Office Action Summary

10/694,134

MOFFATT, WILBUR KEITH

FIG. 1

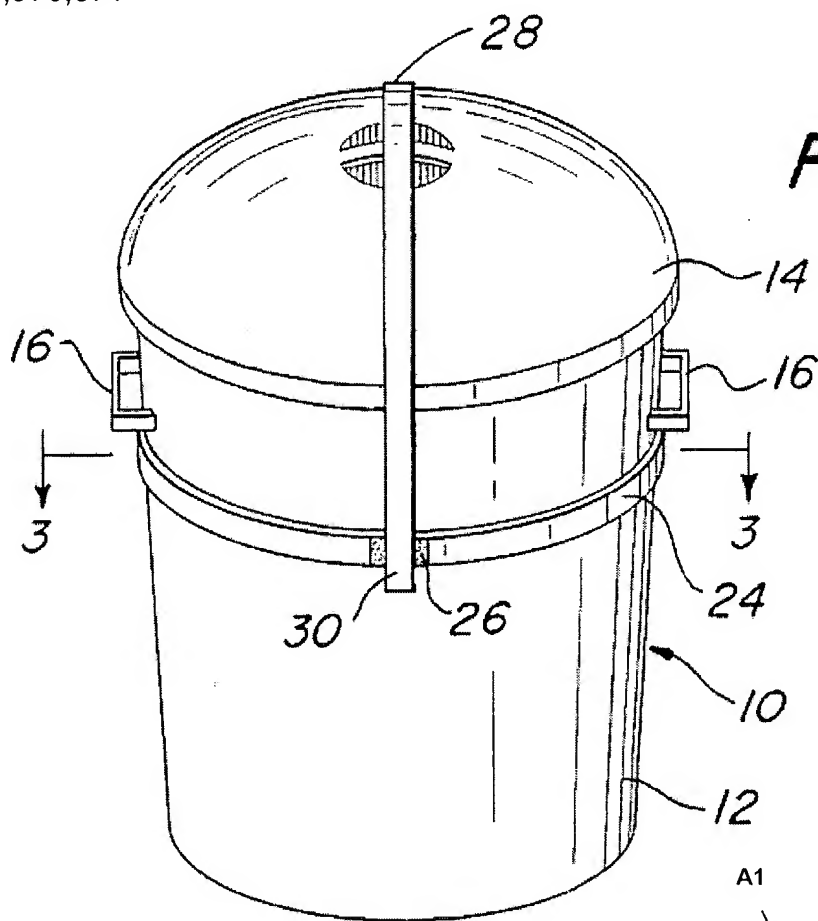
Regarding claim 1, Wise et al. disclose, in Figures 1 and 2, a retainer assembly comprising a first section **A1**, a second section **A4**, a third section **24**, and an outer pole **12**. The first section **A1** has a first portion **A2** and a second portion **30**. The second section **A4** has a first portion **A5** and a second portion **36**. The third section **24** is positioned around the outer pole **12** which is fastened to the second portion **30** of the first section **A1** and the second portion **36** of the second section **A4**.

However, Wise et al., fail to disclose the first portion **A2** of the first section **A1** and the first portion **A5** of the second section **A4** able of fastening to one another across an open end of the outer pole to retain at least one inner pole within the outer pole. Coulter et al. teach a first portion **3A** of a first section **1A** and a first portion **3B** of the second section **1B** able of fastening to one another across an open end of an outer pole **10** to unfasten the retainer assembly from an open end of the outer pole instead from a side as taught by Wise et al. Therefore, as taught by Coulter et al., it would have been obvious to one of ordinary skill in the art at the time the invention was made to modify Wise et al. to be able to fasten the first portion of the first section with that of the first portion of the second section across an open end of the outer pole versus from the side of the outer pole.

Regarding claim 2, the first section **A1**, the second section **A4**, and the third section **24** are at least partially formed of hook and loop fastener material.
